**MEMORANDUM
OFFICE OF THE STATE ENGINEER
HYDROLOGY BUREAU**

DATE: November 15, 2022
TO: David Otori, Permit Lead, Mining Act Reclamation Program (MARF)/MMD
Holland Shepherd, Program Manager, MARF/MMD
THROUGH: Katie Zemlick, Ph.D., Chief, Hydrology Bureau *KZ*
Laura Petronis, Water Resources Manager 1, Hydrology Bureau *LJP*
FROM: Brad Wolaver, Ph.D., Senior Hydrologist, Hydrology Bureau *BDW*
Christopher E. Angel, P.G., Senior Hydrologist, Hydrology Bureau *CEA*
SUBJECT: Review and Comments, Revision 22-1 to Mt. Taylor Mine, Permit No. CI002RE,
Rio Grande Resources Corporation

SUBJECT: **Request for Review and Comment, Mt. Taylor Mine and Mill, Updated Closure/Closeout Plan, Revision 22-1, Cibola County, New Mexico Mining Act Permit No. CI002RE, Revision 22-1**

Subject: **New Mexico Environment Department (NMED) Comments, Updated Closure/Closeout Plan, Revision 22-1, Mt. Taylor Mine, Rio Grande Resources, Cibola County, New Mexico, New Mexico Mining Act Permit No. CI002RE**

**Appendix A. Mine Shaft Proposed Design with Pump Stations and Stratigraphy
(Drawing No. 1000-03)**

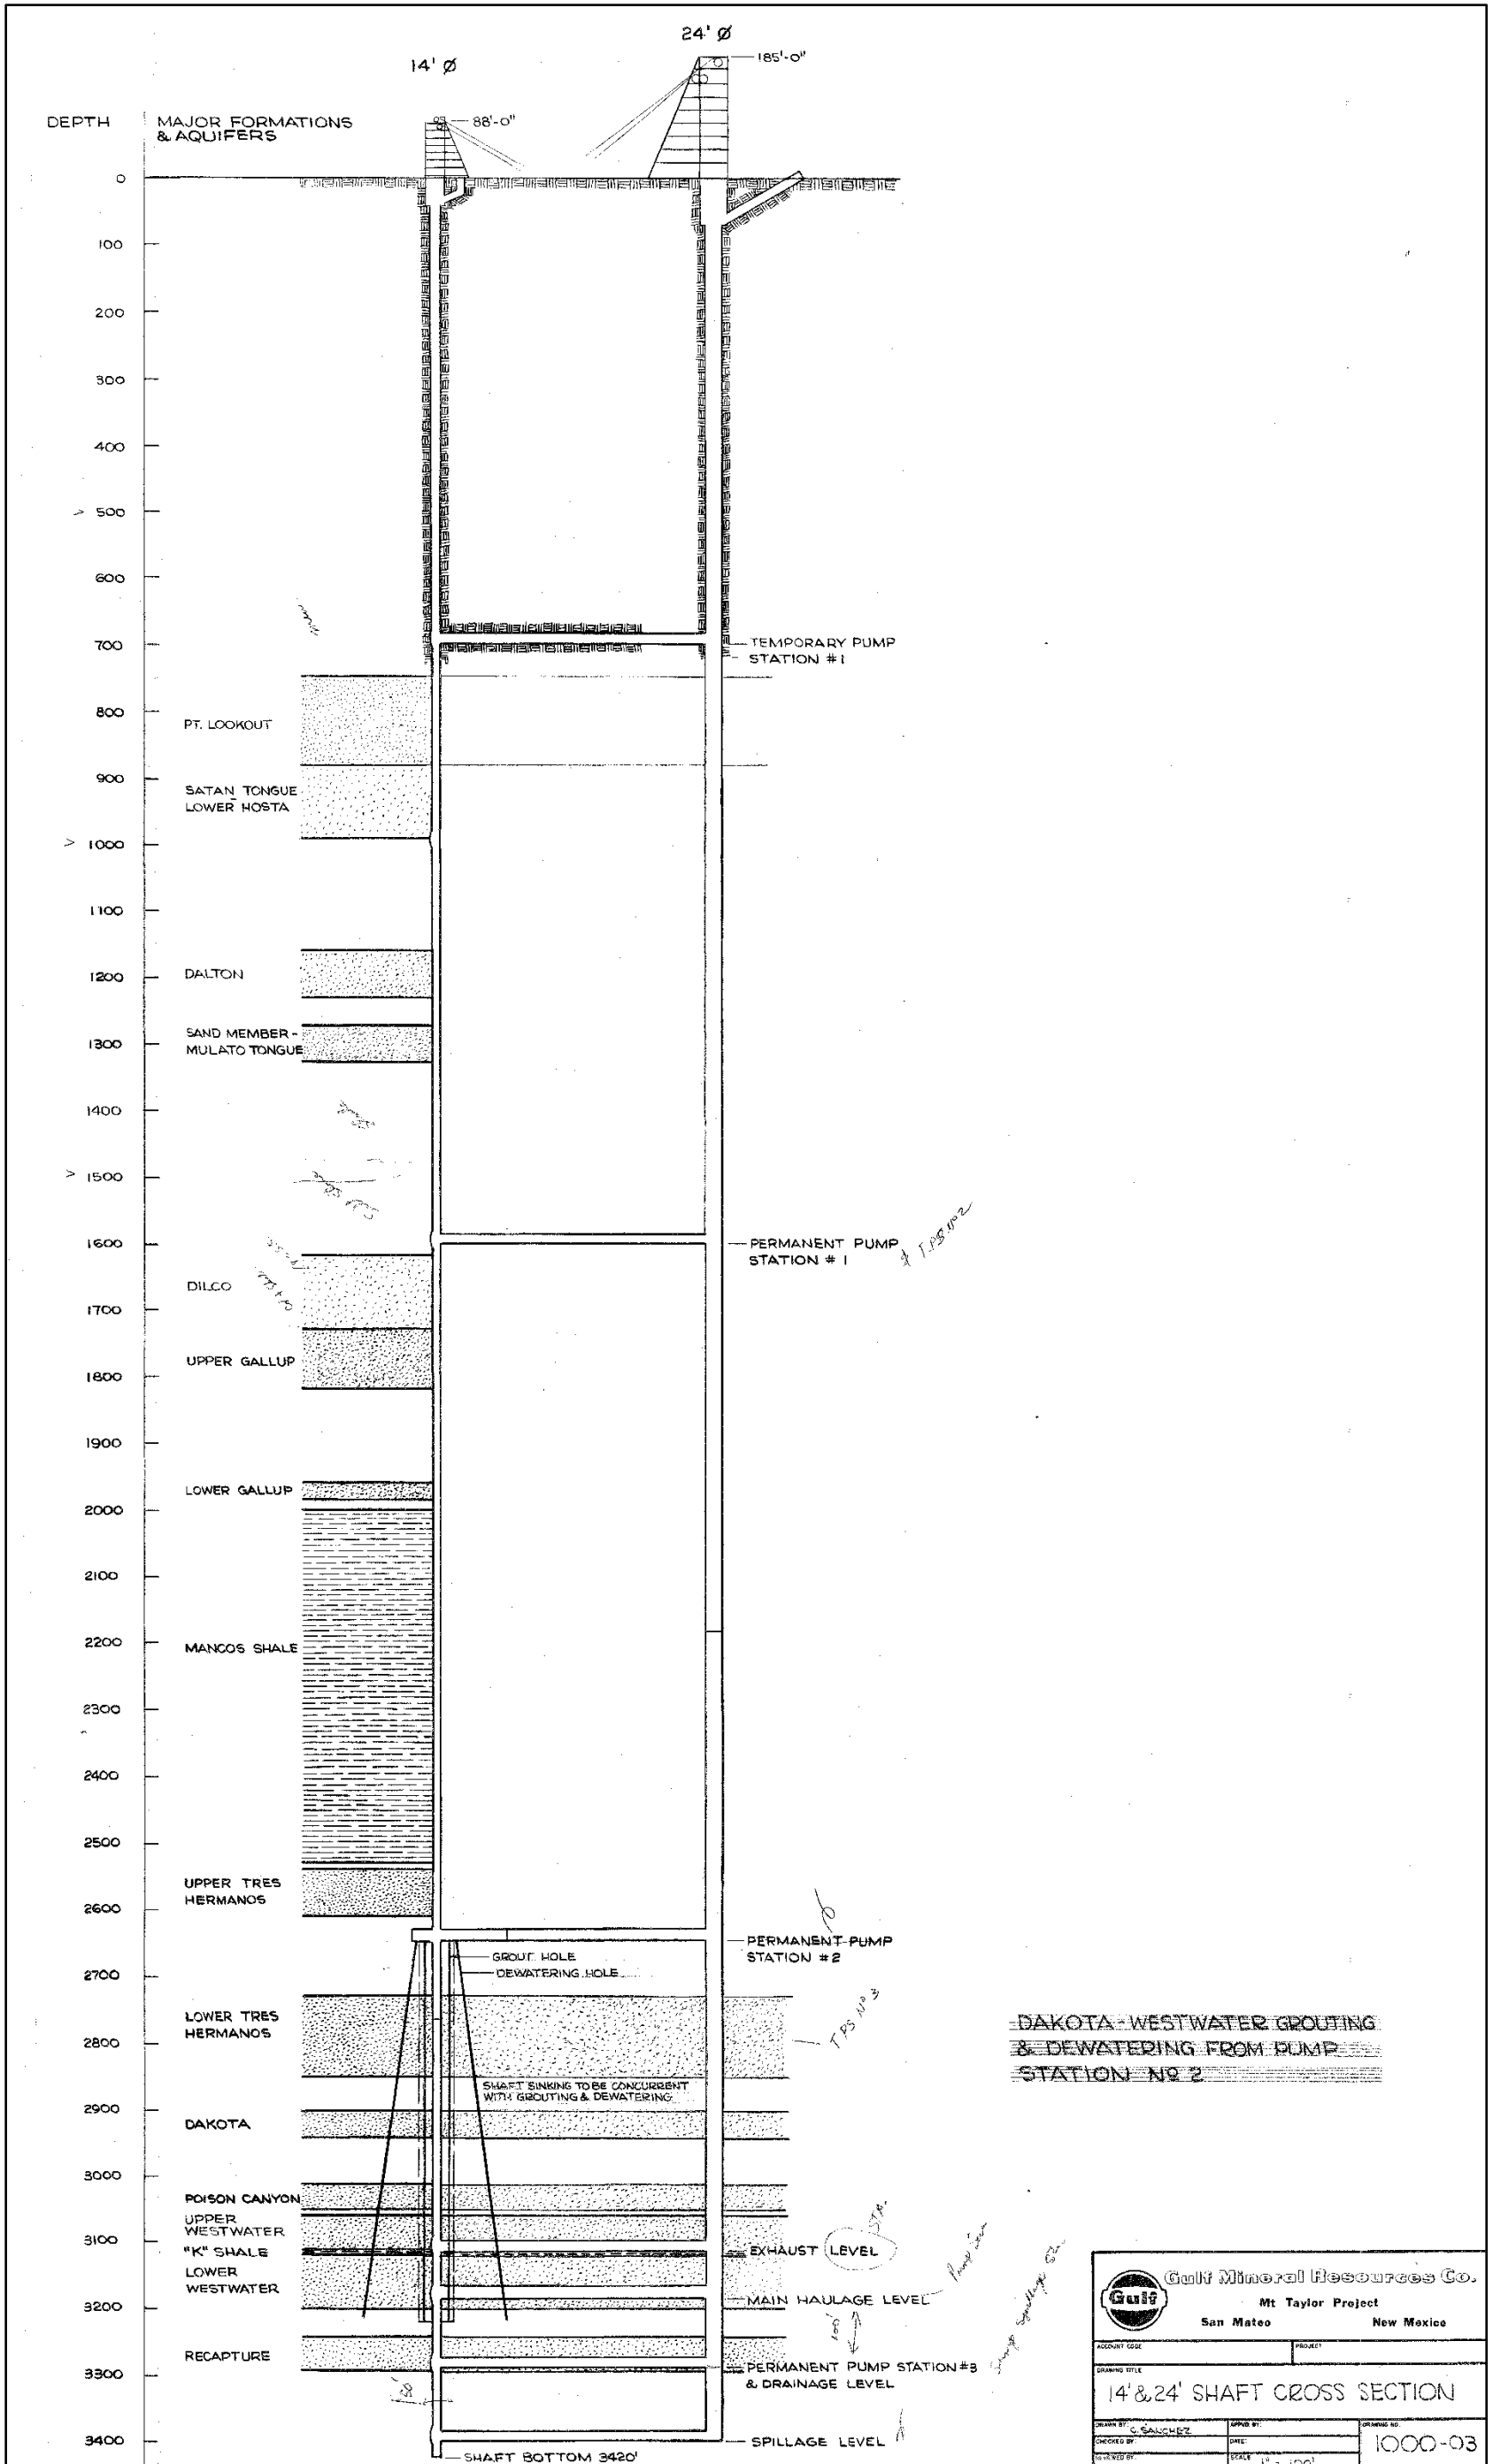
The shafts do not conform to NMOSE codes as outlined in, but not limited to 19.27.4.29, 19.27.4.30.A (Annular seal), and 19.27.4.31 NMAC. In their current condition, the shafts are considered by NMOSE to be abandoned in-place without a permit. Thus, Hydrology's interpretation of the Administrative Code indicates that RGR should seal off the Westwater Canyon in the shafts to prevent groundwater with elevated uranium and radium-226 from migrating to other hydrogeologic units, and 1) prevent commingling or inter-aquifer exchange of groundwater, 2) prevent loss of hydraulic head between hydrogeologic zones or units, 3) prevent unintended flood waters, surface water, or groundwater from entering the shafts and contaminating the aquifer, and 4) prevent the flow of contaminated or low-quality water. If RGR does not plan to plug the shafts from the bottom up, the Administrative Code requires that RGR apply for a variance per code 19.27.4.37 NMAC. The Administrative Code also indicates that the seep in the fourteen-foot shaft should be sealed off. Also, concrete shaft liners will break down over time and create the possibility of leakage. Thus, Hydrology's interpretation of the Administrative Code indicates that RGR should provide a Shaft Monitoring Plan that describes how RGR will demonstrate compliance with the above referenced codes. Hydrology's interpretation of the Administrative Code also indicates that RGR should not free-fall construction debris into the shafts to reduce risk of damaging shaft liners and that RGR should propose a design of a lock box or similar fixture to protect the PVC vent and monitoring tube from damage and potential migration of surface runoff into the shafts (including but not limited to Section 27.4.29.K and Section 27.4.29.L NMAC).

Prior to shaft construction, a grout design with permeability of 10^{-9} cm/s was proposed (i.e., Celcite 55 Terraseal; **Appendix A**). However, as-built documentation was not provided by RGR describing if this grout was injected into the formation. A 1977 report on grouting of the Dakota (**Appendix B**) indicates that grouting had already taken place in the Menefee and Point Lookout; however, the report does not specify as-built materials used for the grouting these intervals. The
